Product Change Notification: PCN-22-143739

General Product Description:
Terminal Contacts

Paper reel change from 999225-1 to 2400473-1

Paper reel appearance status 999225-1 & 2400473-1

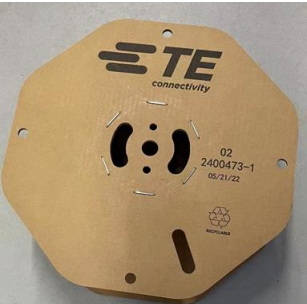
Reel part	Reel status	Fixed method	Different
995225-1	 		<ol style="list-style-type: none"> 1. No hole 2. Fixed of FIBER TAPE

1. Paper core status is different
2. Fixed method is different
3. Flag have small change, two side the circular hole change to the rectangle hole

Reel part	Reel status	Fixed method	Different
2400473-1	 		<ol style="list-style-type: none"> 1. Hole on the core 2. Fixed of core hole
